Volume II

In response to Comment I006-309, an analysis was conducted of interim terminal stations for the F-B LGA. The analysis follows below. Although the Technical Appendix is new text, for readability, Technical Appendix 2-I has not been underlined.

Appendix 2-I: Interim Terminal Station

Figure 2-I-1 Interim Terminal Station Concept A

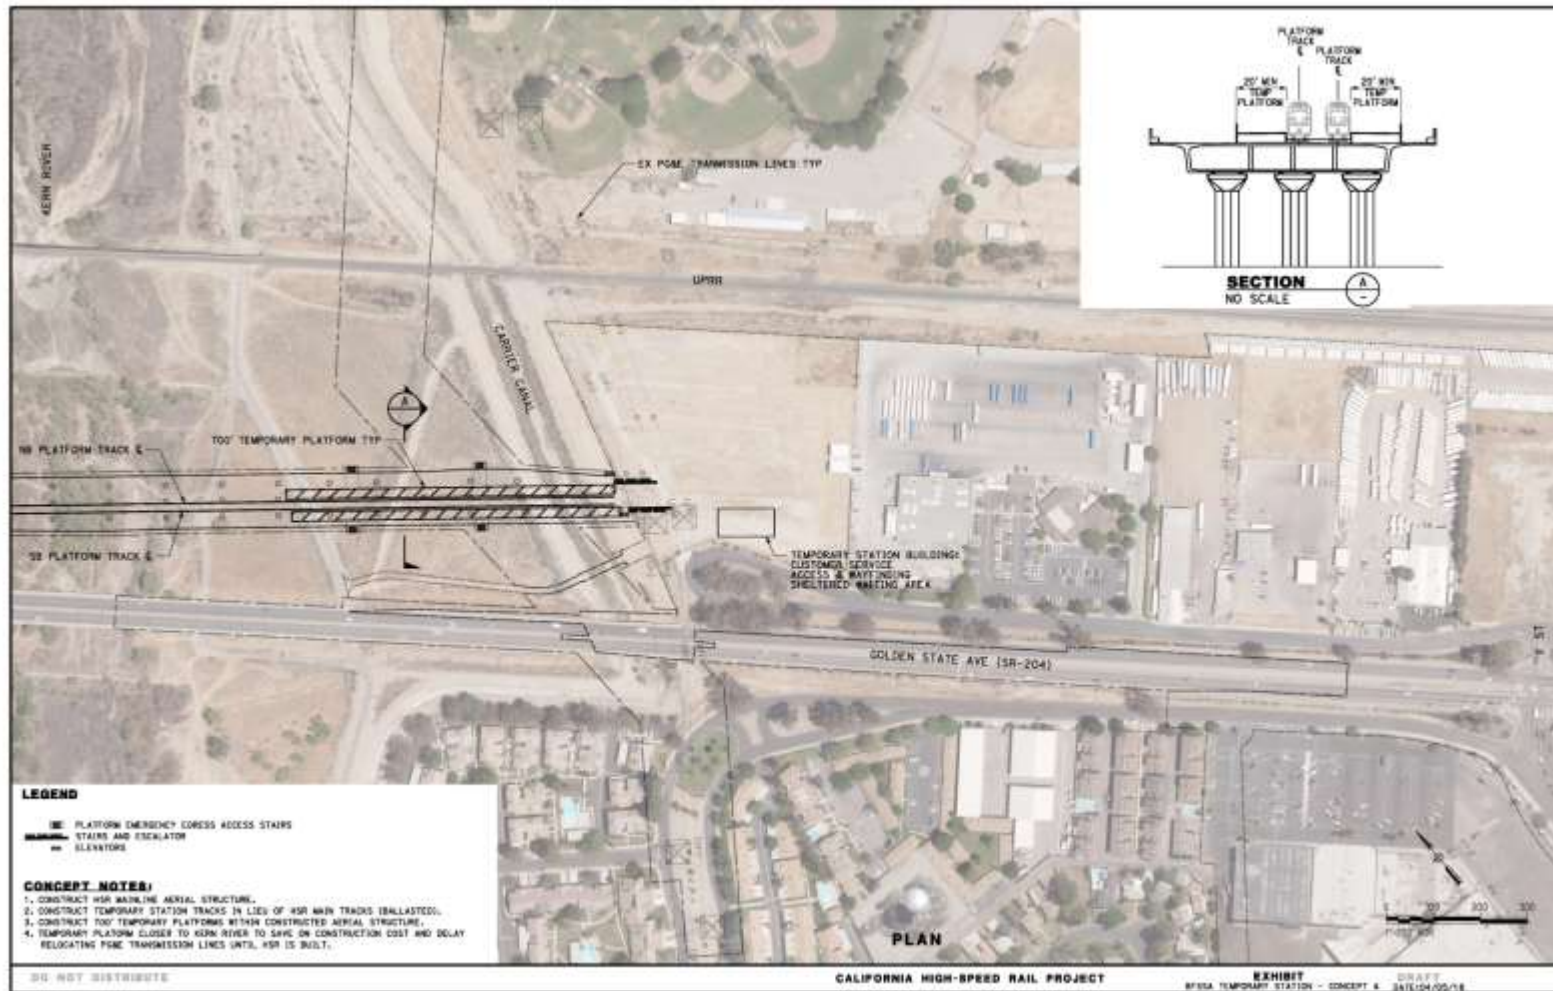
Concept A (Figure 2-I-1) would be an approximately 4.1-acre site³ and would require the construction of temporary platforms (700 feet in length) along the proposed mainline tracks north

of the Carrier Canal. Existing overhead, high voltage power lines would remain in place. Platform access would be provided from the southern end of the platforms, and emergency egress points would be provided between the Carrier Canal and the Kern River. This concept would minimize construction costs by placing the platforms over the Carrier Canal and would include the development of a temporary station building for customer service. Concept A would require removal of temporary features once the full buildout station is constructed. The cost associated with the removal of the temporary features would be calculated based on design plans, if this concept is selected.

Figure 2-I-2 Interim Terminal Station Concept B

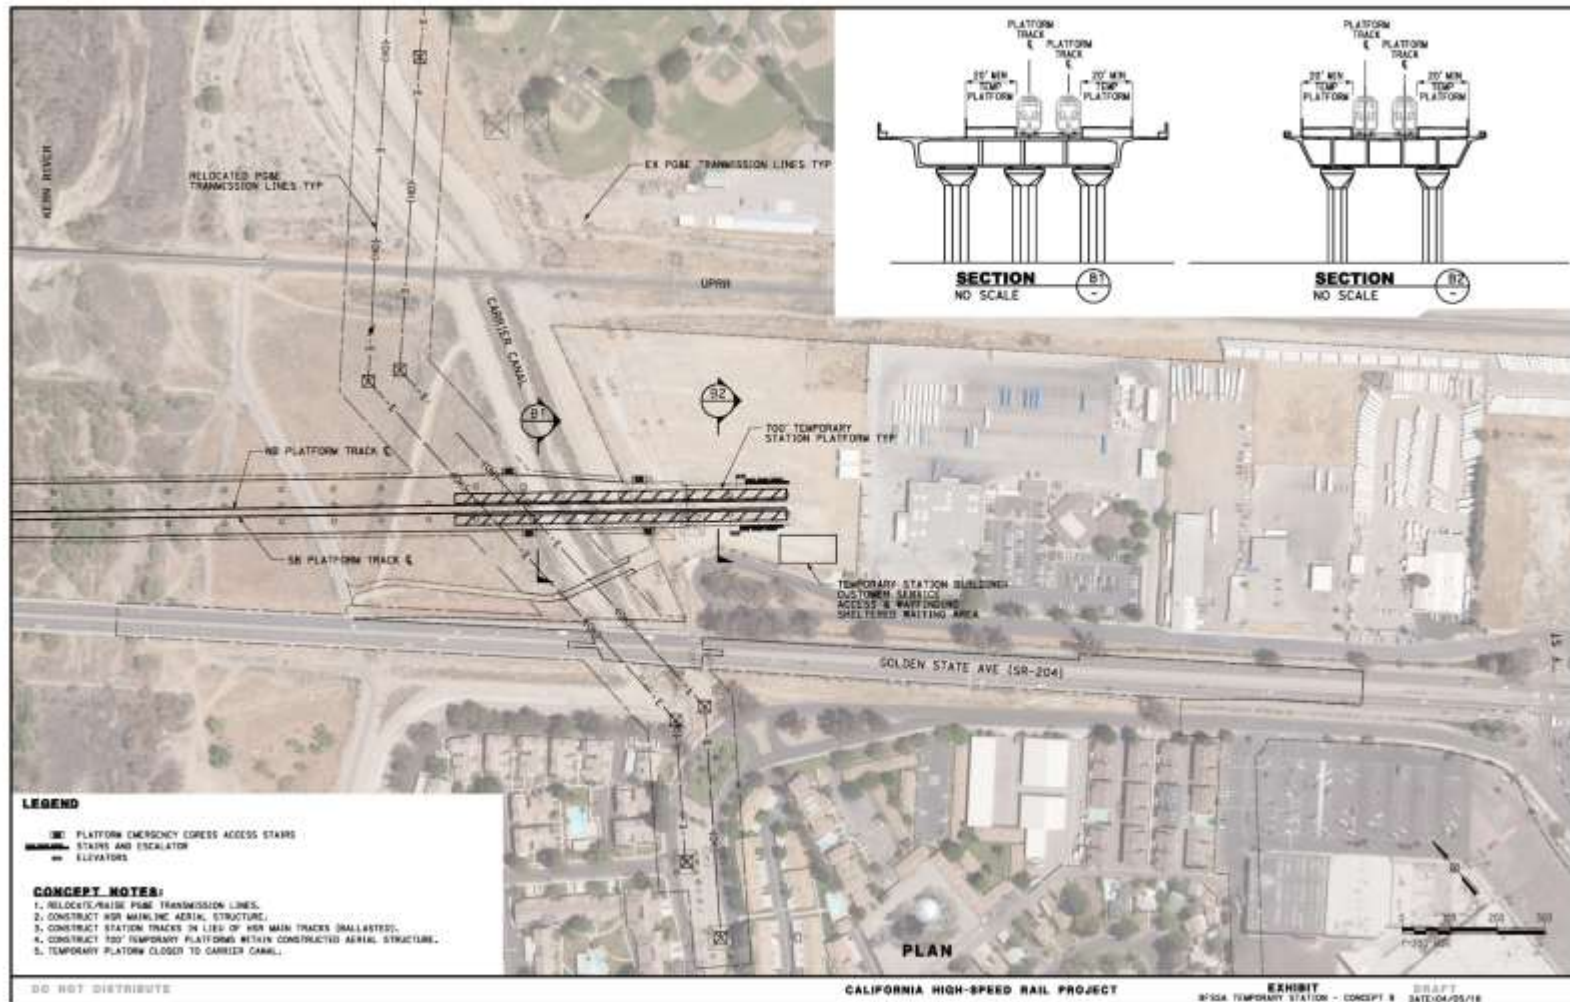
Concept B (Figure 2-I-2) would be an approximately 16.5-acre site and would require the construction of the temporary platforms (700 feet in length) within the proposed station footprint to accommodate egress points on the south side of the Carrier Canal. Temporary platforms would straddle the Carrier Canal and would be constructed along the proposed mainline tracks. Platform access would be provided from the southern end of the platforms. Overhead, high voltage power lines would require relocation and would be located over the northern end of the temporary platform. This concept would include the development of a temporary station building for customer service. Concept B would require removal of temporary features once the full buildout station is constructed. The cost associated with the removal of the temporary features would be calculated based on design plans, if this concept is selected.

Figure 2-I-3 Interim Terminal Station Concept C

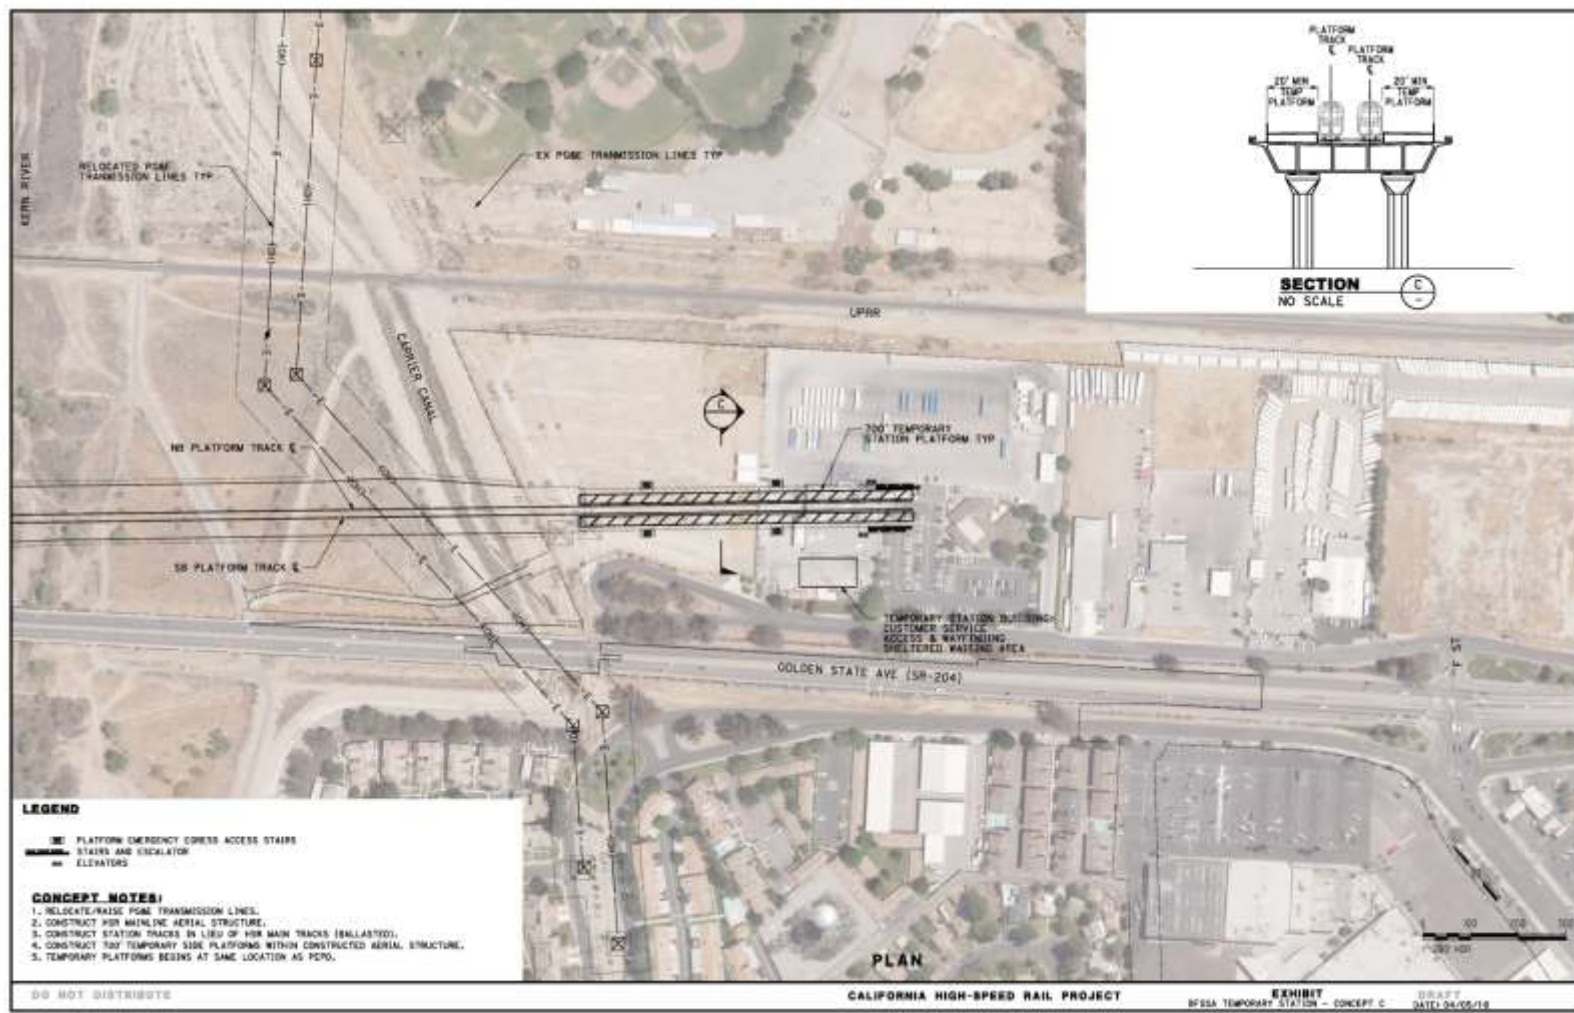
Concept C (Figure 2-I-3) would be an approximately 16.5-acre site and would require the construction of the temporary platforms (700 feet in length) entirely on the south side of the Carrier Canal and along the proposed mainline tracks. Access under Concept C would occur anywhere along the platform for both normal use and emergency egress. Overhead, high voltage power lines would require relocation. This concept would include the development of a temporary station building for customer service. Concept C would require removal of temporary features once the full buildout station is constructed. The cost associated with the removal of the temporary features would be calculated based on design plans, if this concept is selected.

Figure 2-I-4 Interim Terminal Station Concept D

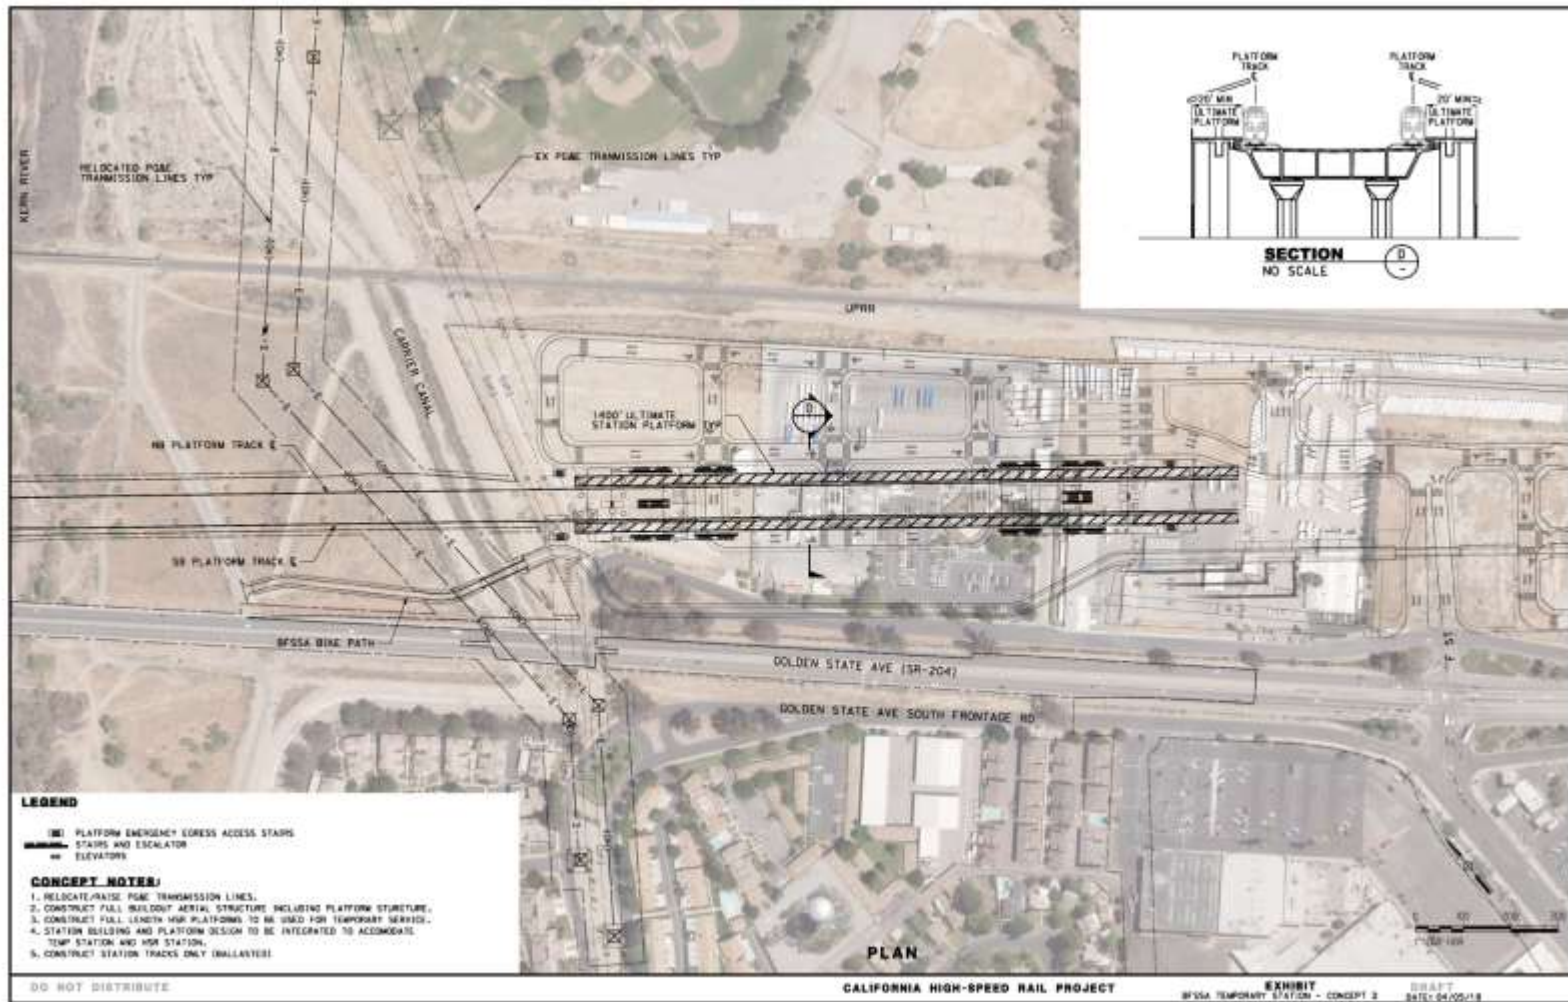
Concept D (Figure 2-I-4) would be an approximately 16.5-acre site and would be the most expensive of the four concepts, because it would require construction of the proposed full buildout features in their proposed locations including the station tracks and platforms (1,400 feet in length). Mainline and station track alignments would be constructed in their permanent position with only minor shifts in turnout locations. Concept D would require the relocation of the overhead, high voltage power lines. Mainline and station track alignments under Concept D would be constructed in their permanent positions; therefore, under Concept D, there would be no throw away costs due to the removal of temporary features.

Appendix 3.19-A
Figure 1
Planned and Potential Projects and Plans
Kern County

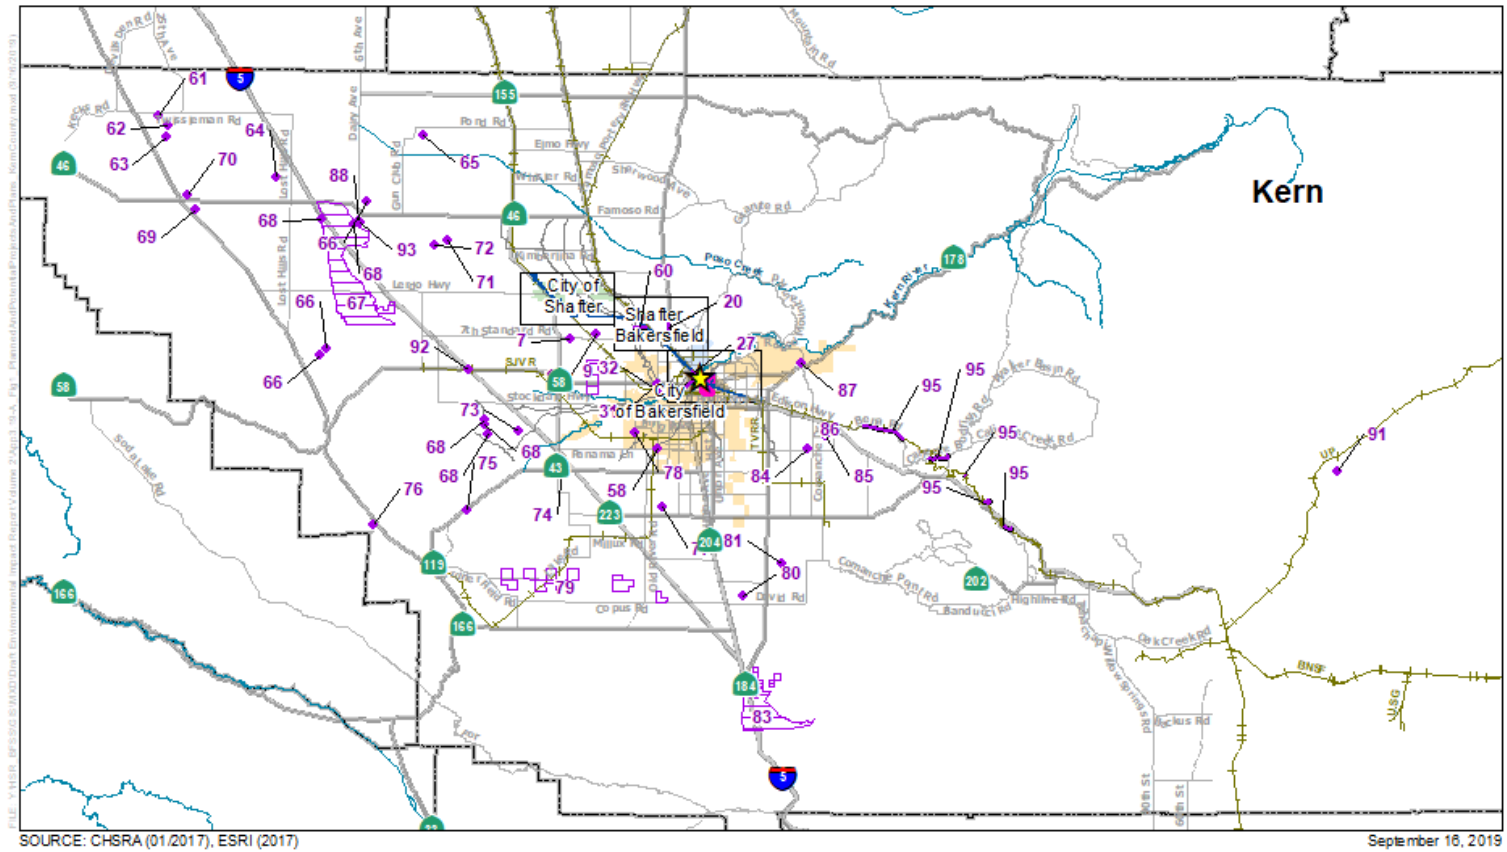
Appendix 3.19-A Figures 1-4 were also factually corrected to include the Making Downtown Bakersfield Station Area Vision Plan boundary; see below.

Appendix 3.19-B
Figure 1
 Planned Transportation Projects
 Kern County

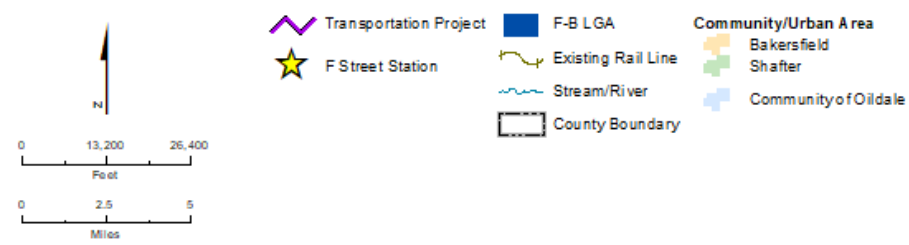
Appendix 3.19-B Figures 1-4 were factually corrected to include the three additional projects in Table B-3, described above, as well as labels for the communities of Oildale and East Bakersfield; see below.
